POWERTECH (USA) INC.

RE: Revised Technical Report (TR); Powertech (USA) Inc.'s Proposed Dewey-Burdock Project; Docket No. 40-9075

CHANGE INDICES

² Inyan Kara indicates that screened interval includes both Chilson and Fall River.

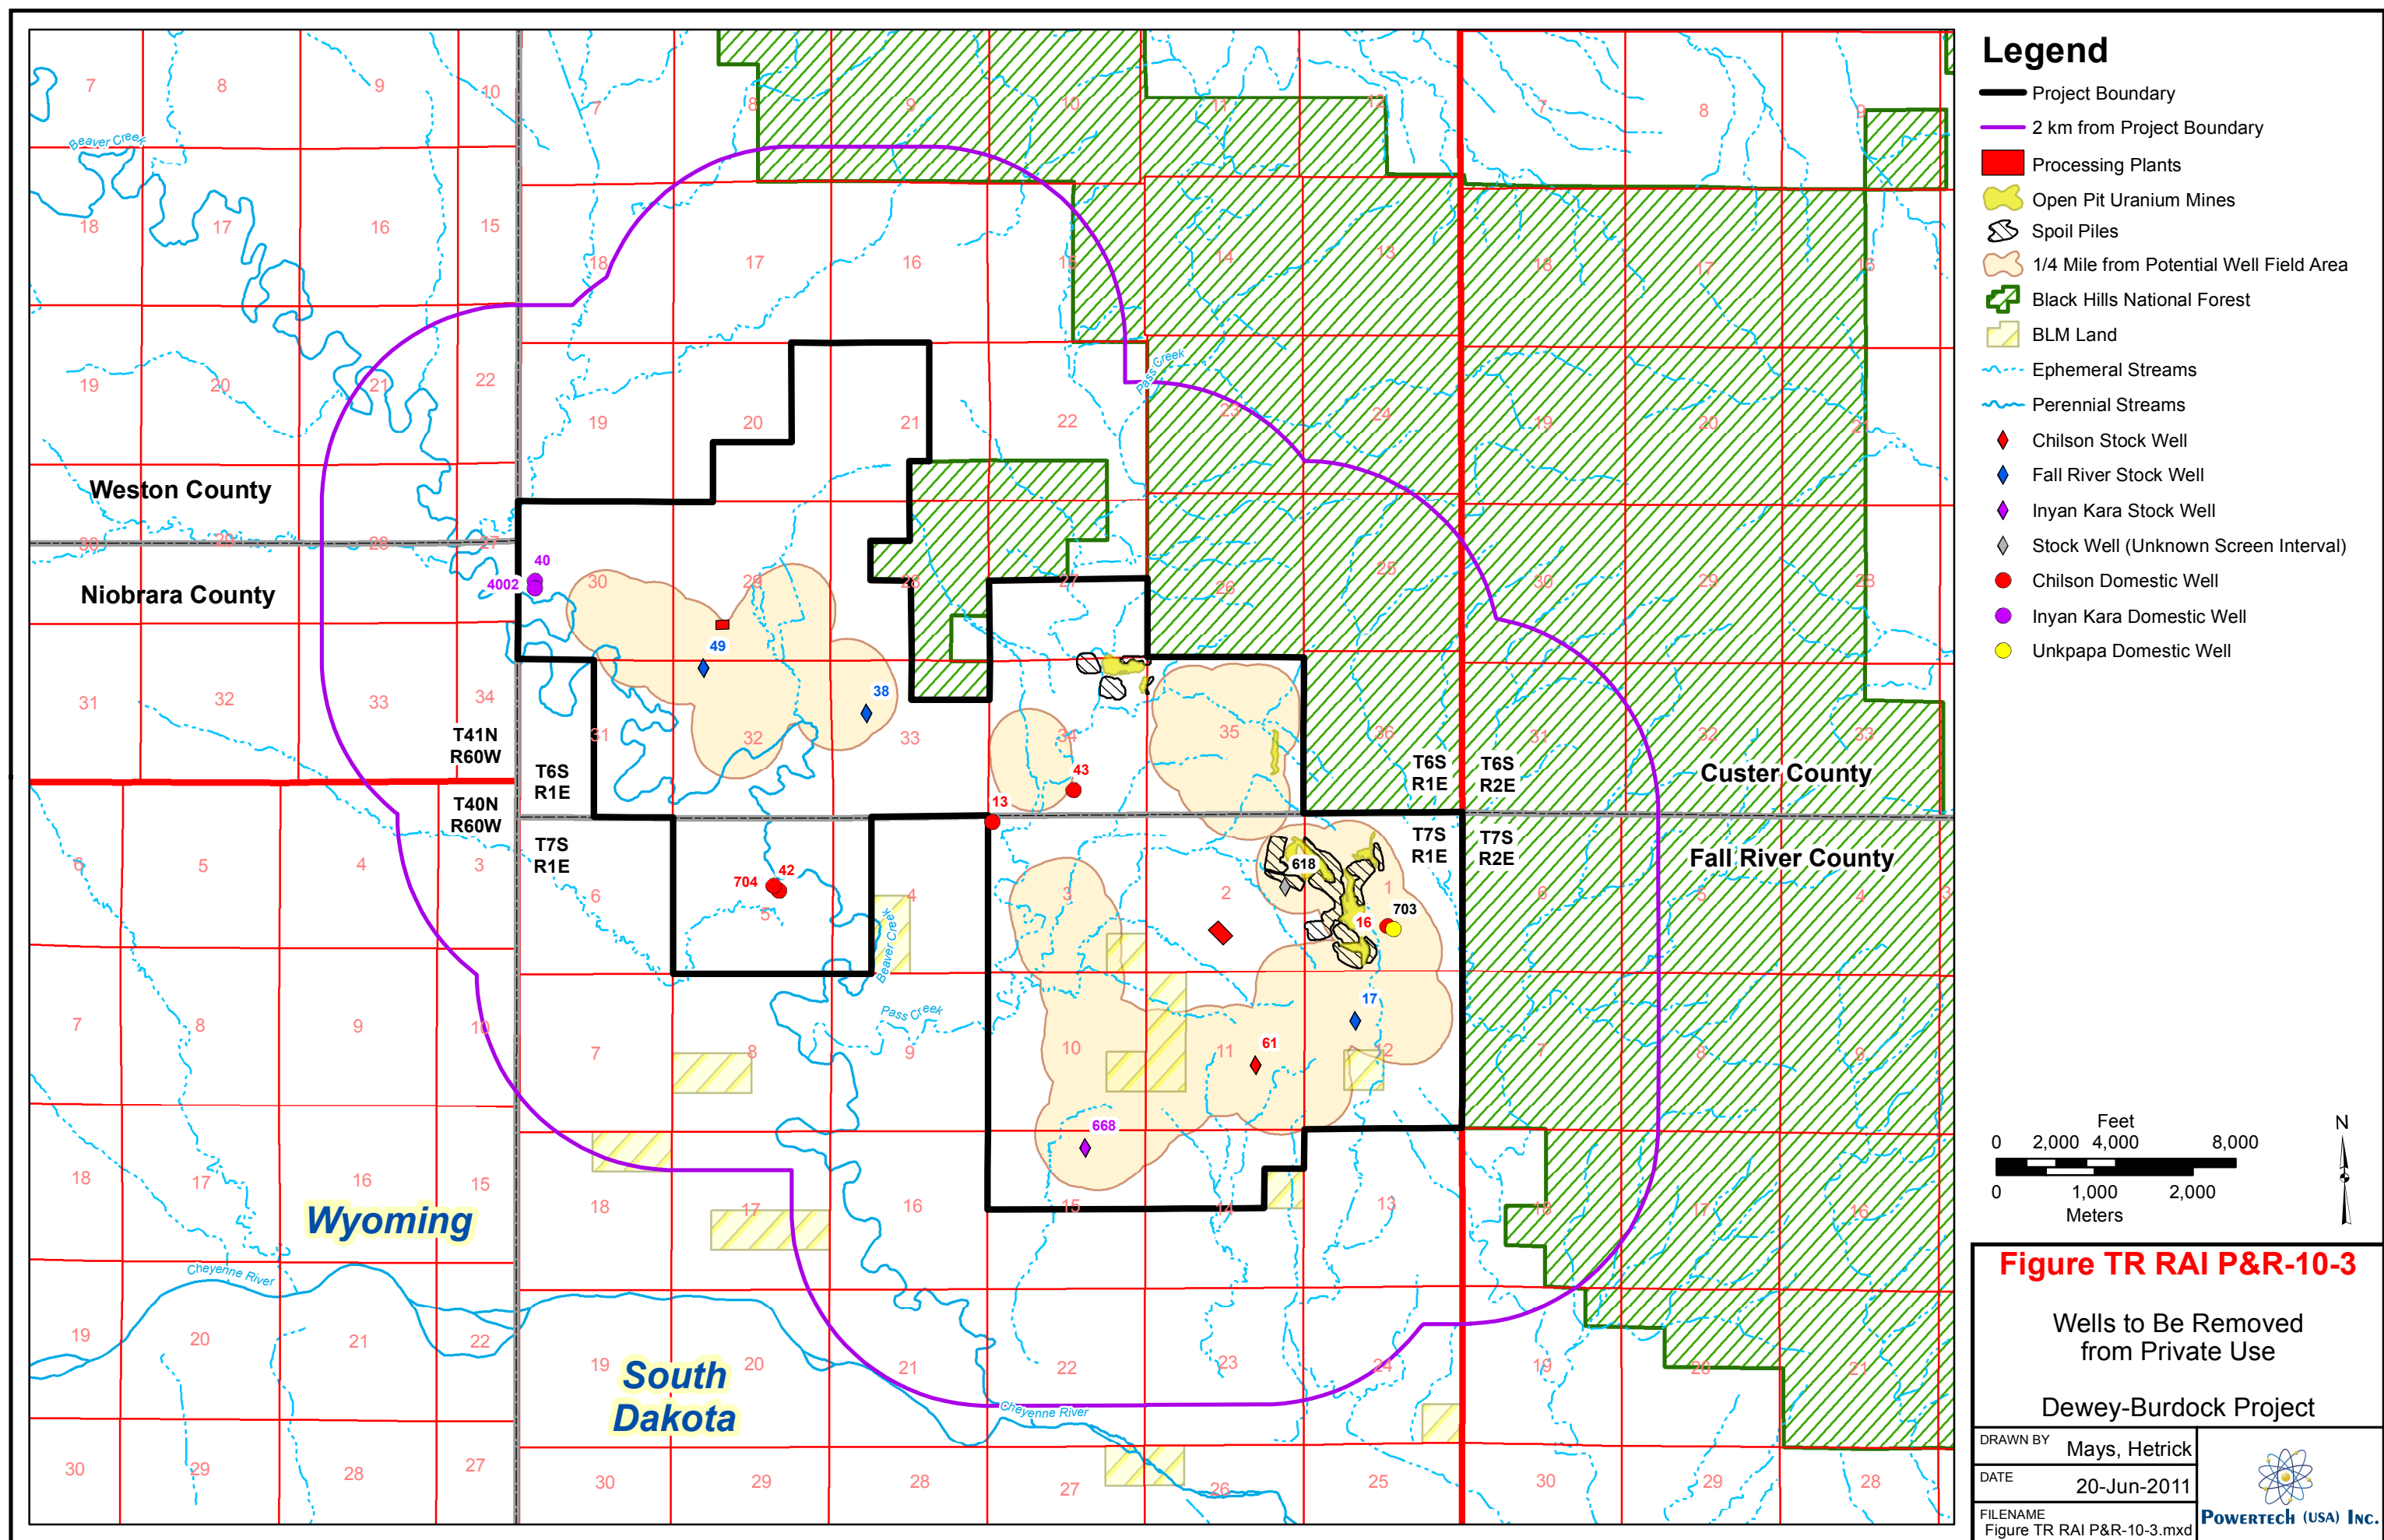
Revised tables presenting the inventory of all wells within 2 km (1.2 miles) of the project boundary are provided within this response. Well completion records and associated documentation will be provided in Appendix 2.2-B in the revised TR. Exhibit 3.1-1 of the TR has been revised to include all wells within 2 km of the project boundary and is included with this response package. The revised Exhibit 3.1-1 also will be included with the revised TR. The following information will be incorporated into the revised TR.

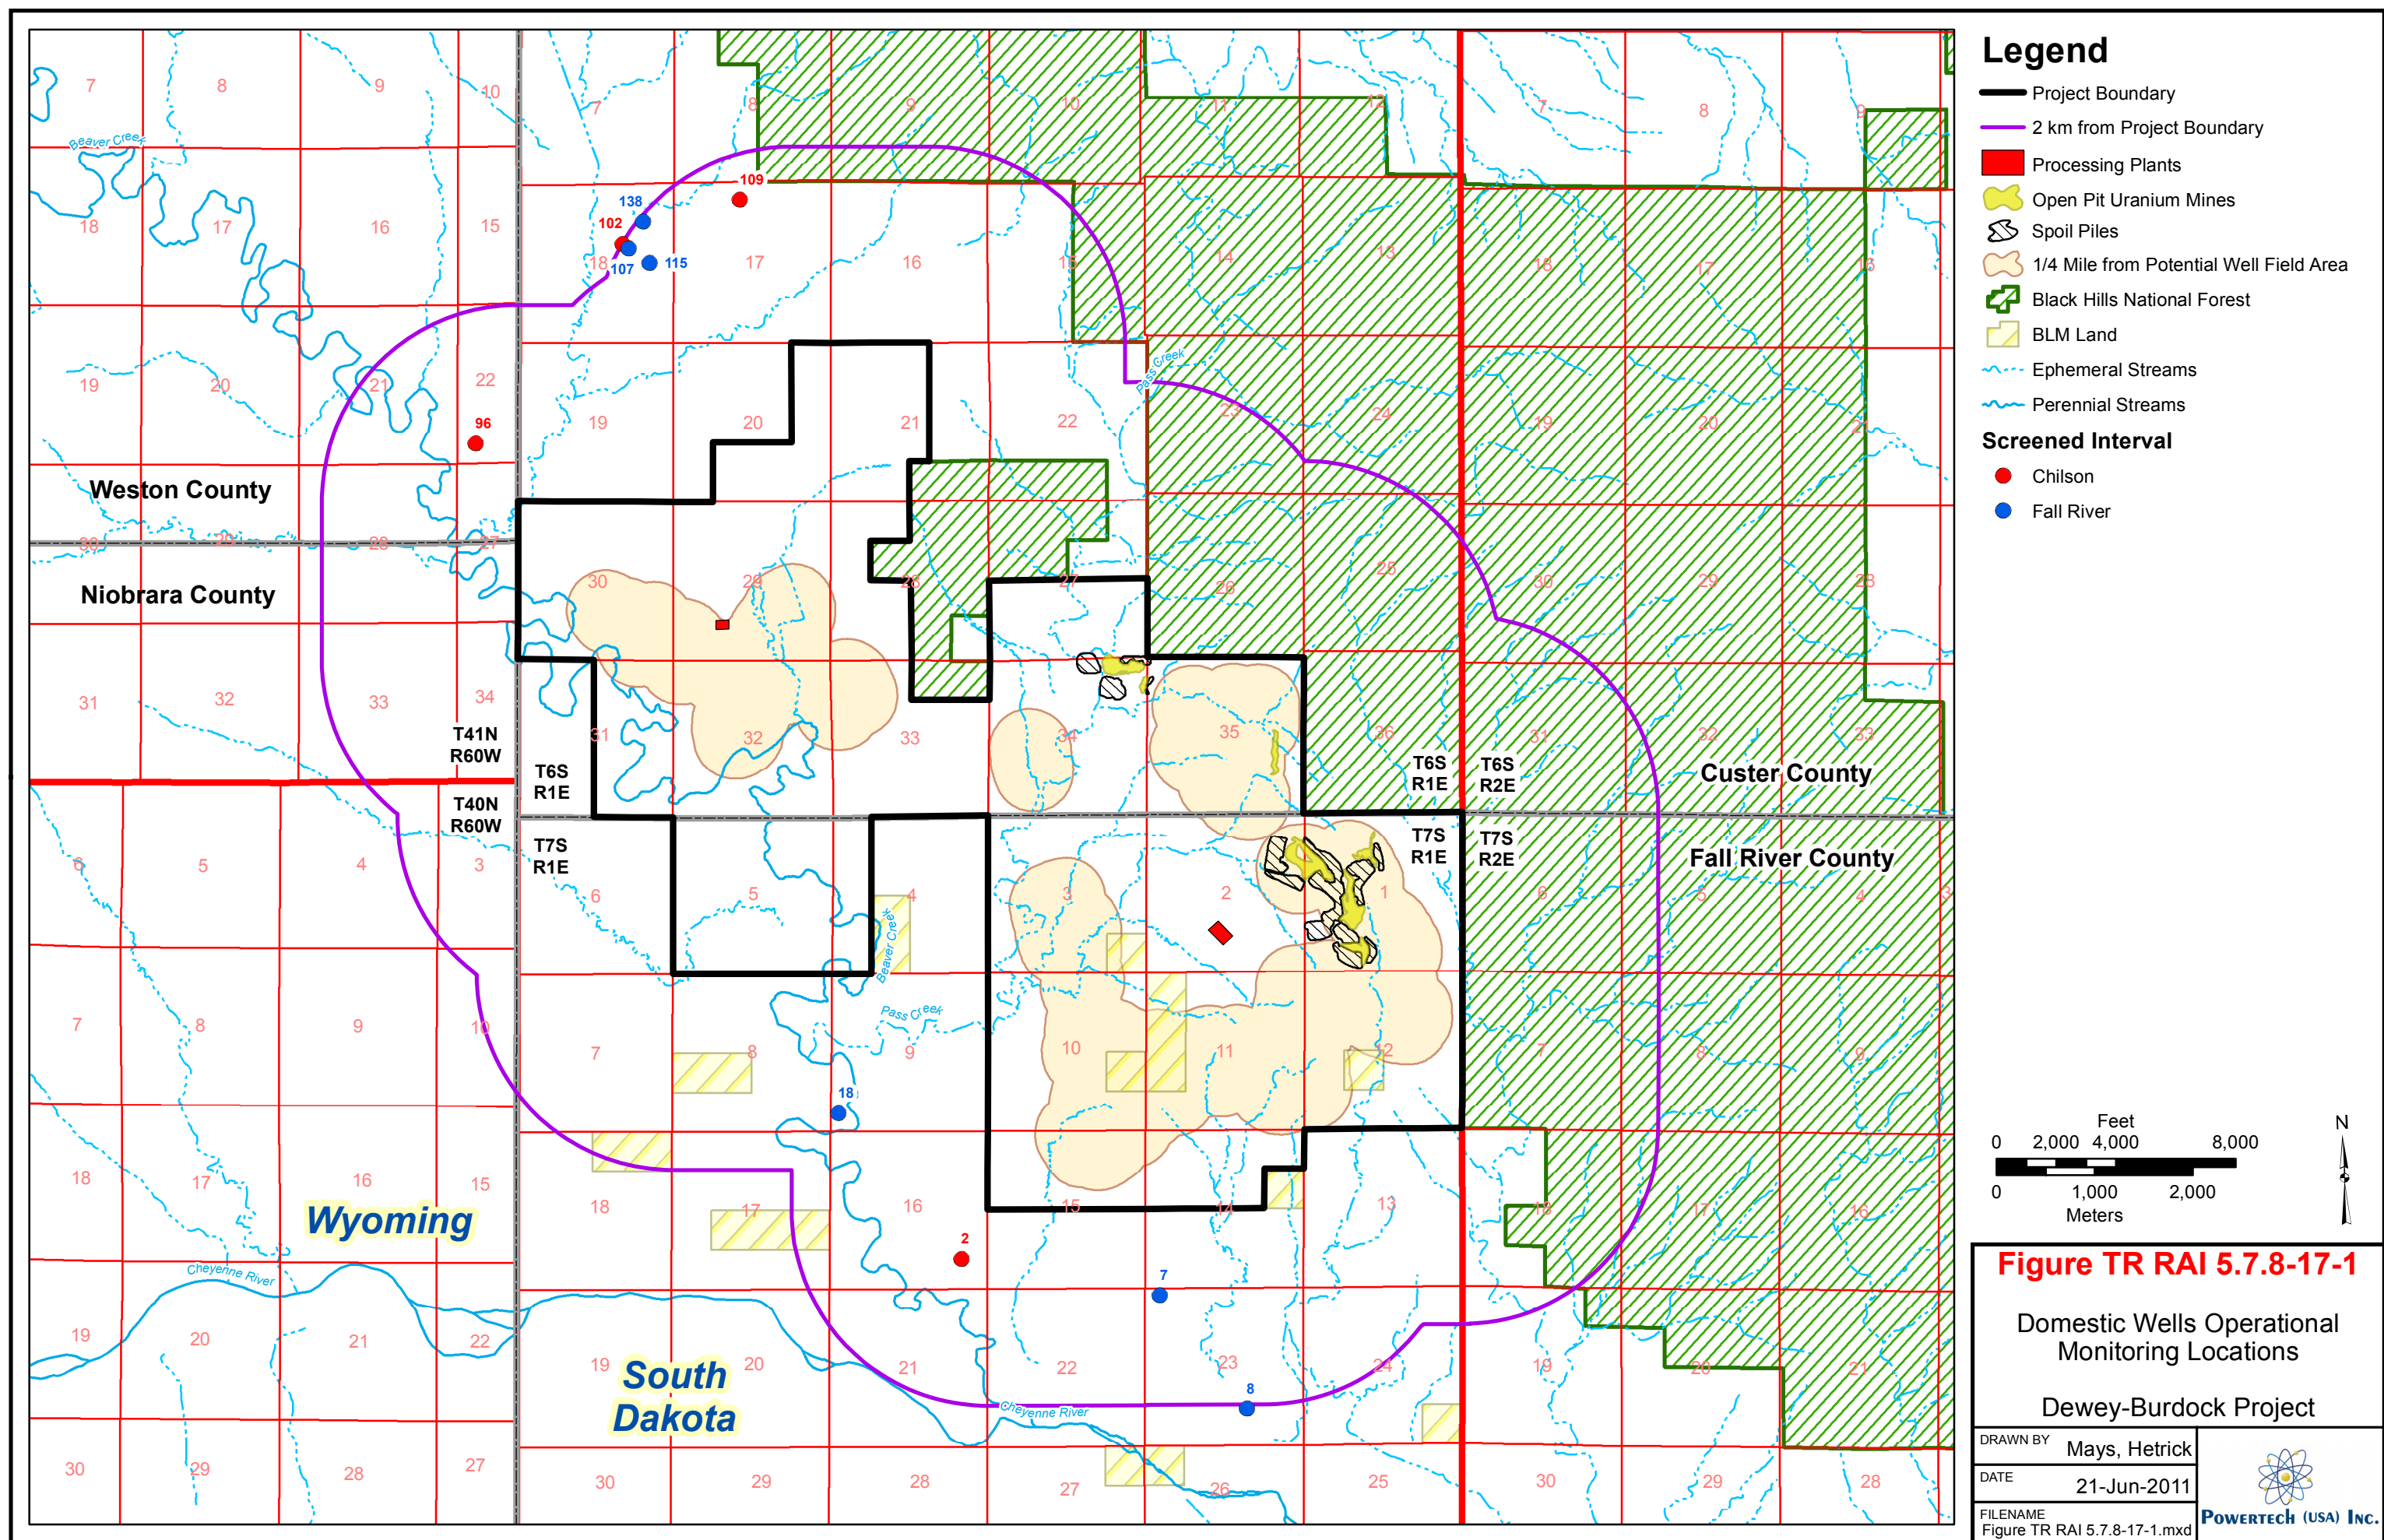
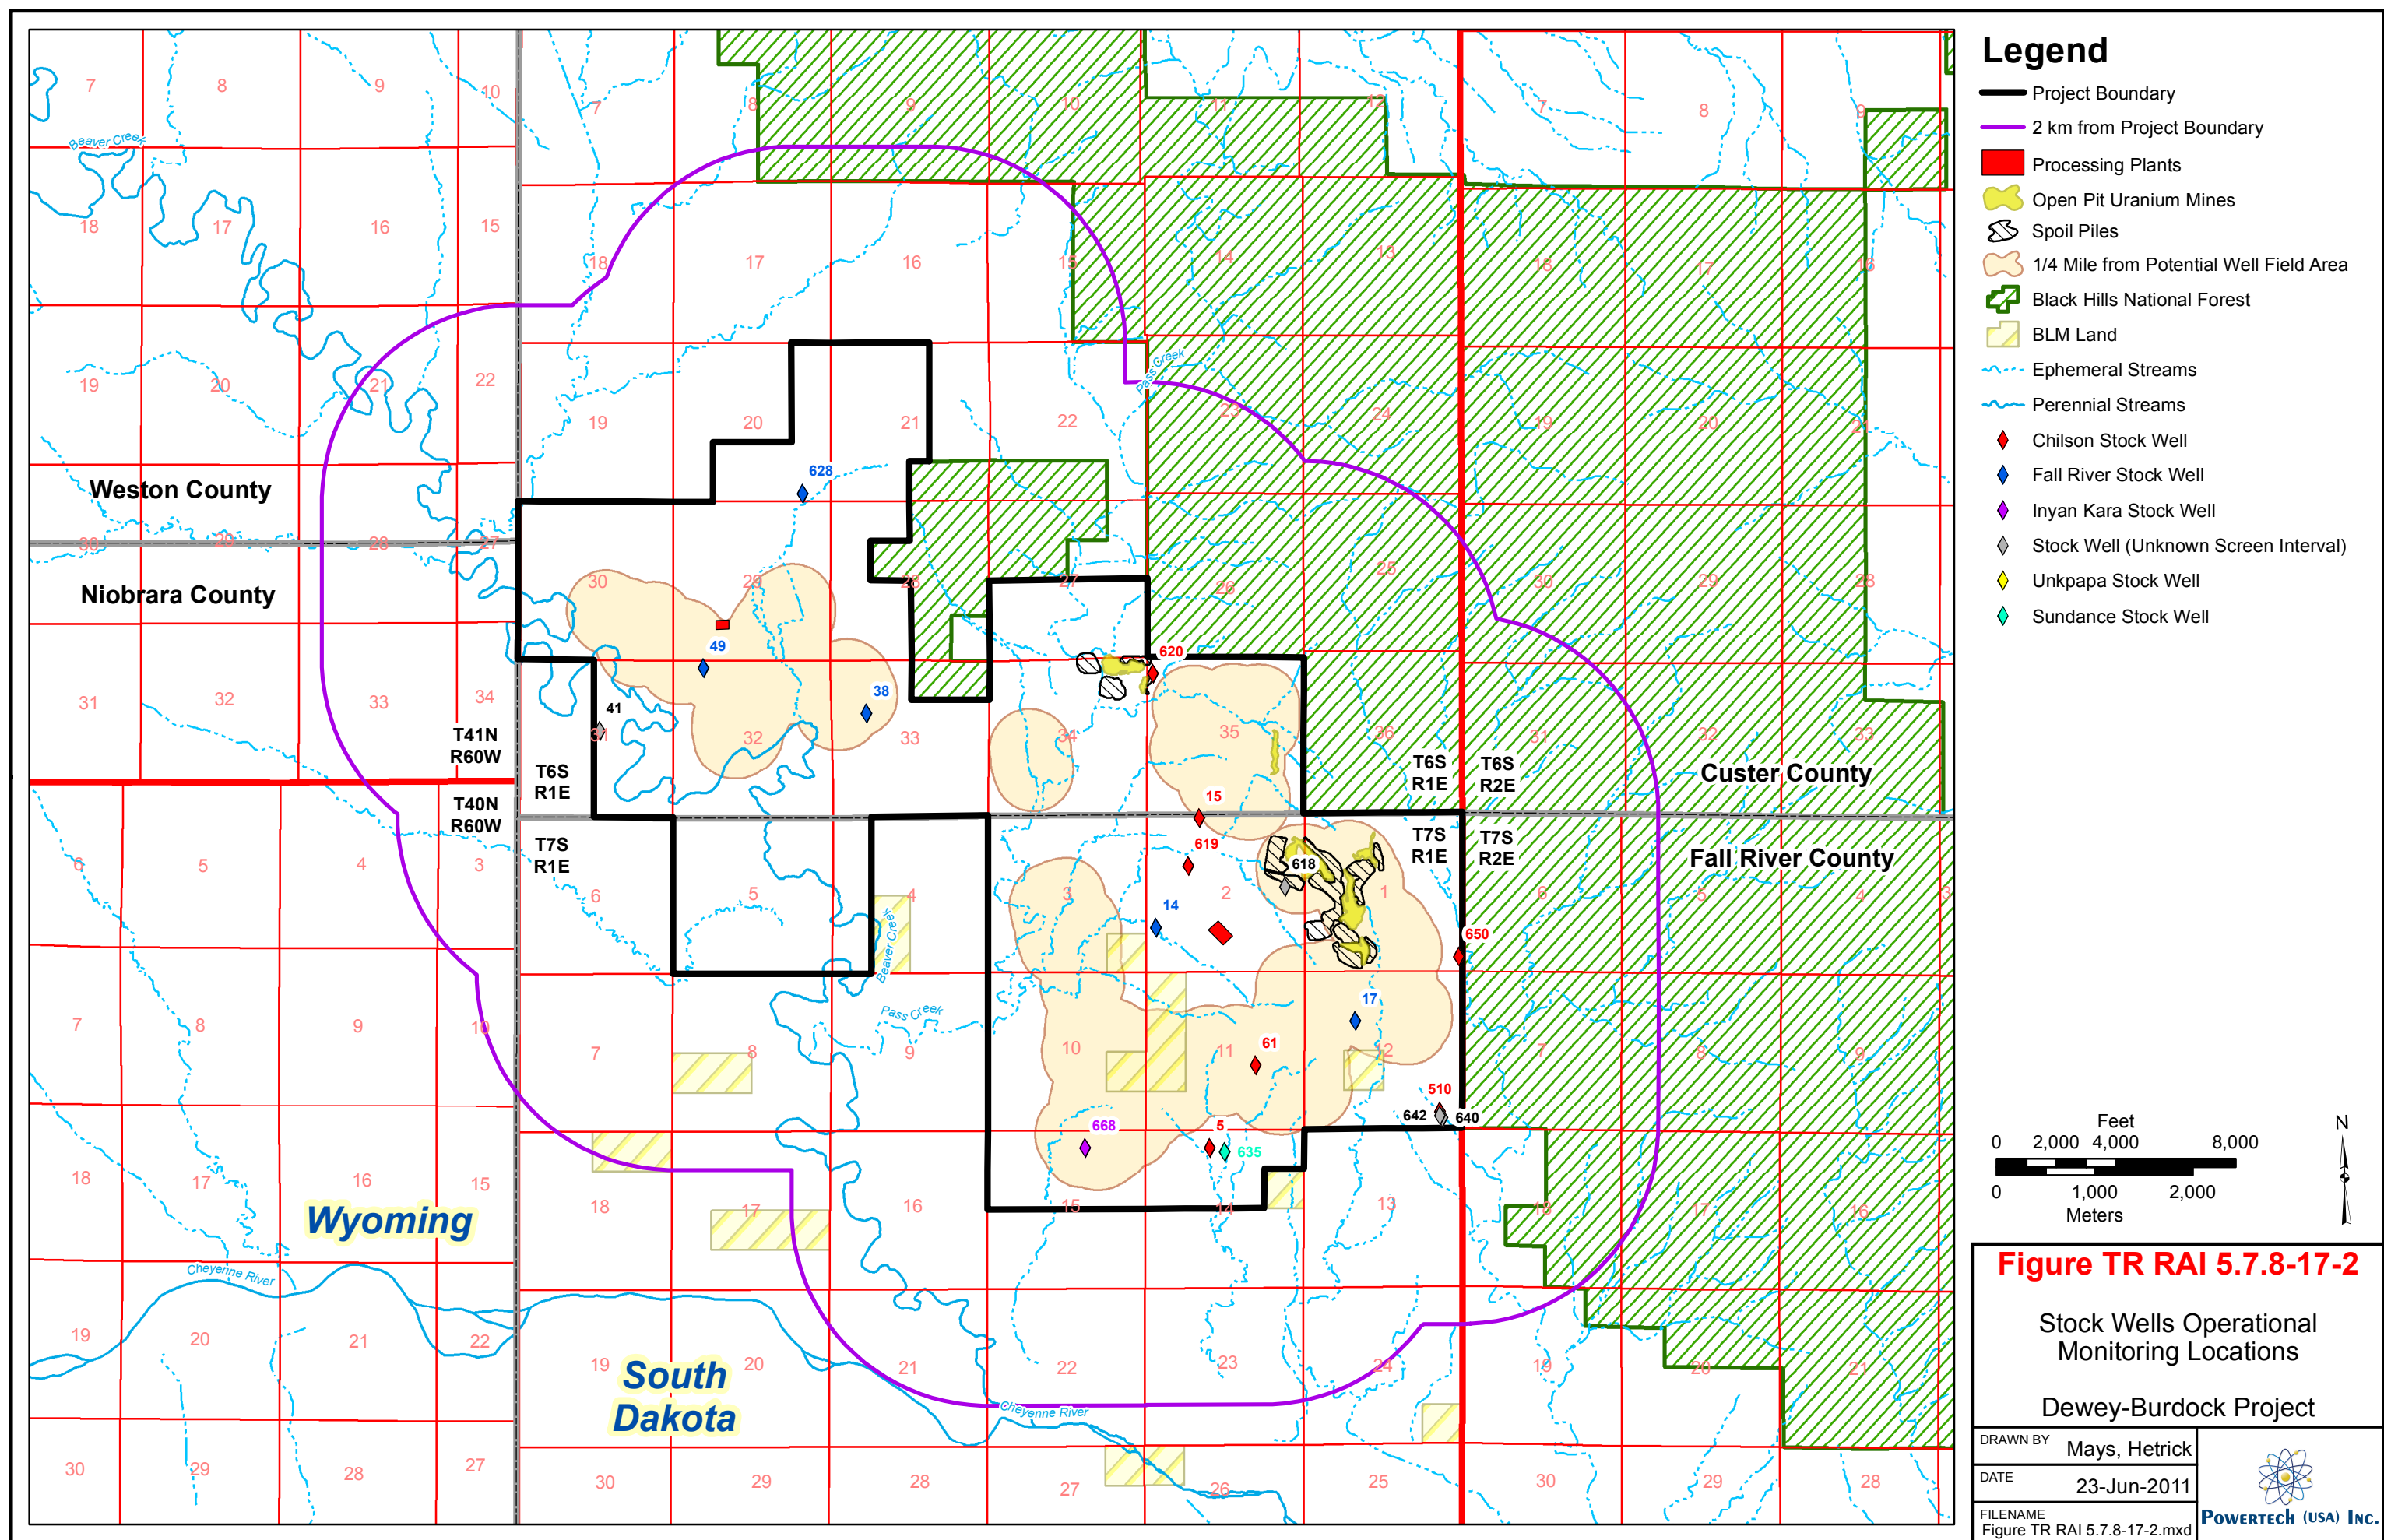
Section 5.7.8 of the TR states, "Quarterly samples will be collected from drinking water and livestock wells, included in the groundwater sampling sites as shown in Figure 5.7-10." This statement implies there are more proposed well sampling locations than what is shown in Figure 5.7-8. NRC staff notes that numerous Inyan Kara wells in Appendix 2.2-A are close to well fields within the license boundary and are not included in Figure 5.7-10. Please specify all water well sampling locations.
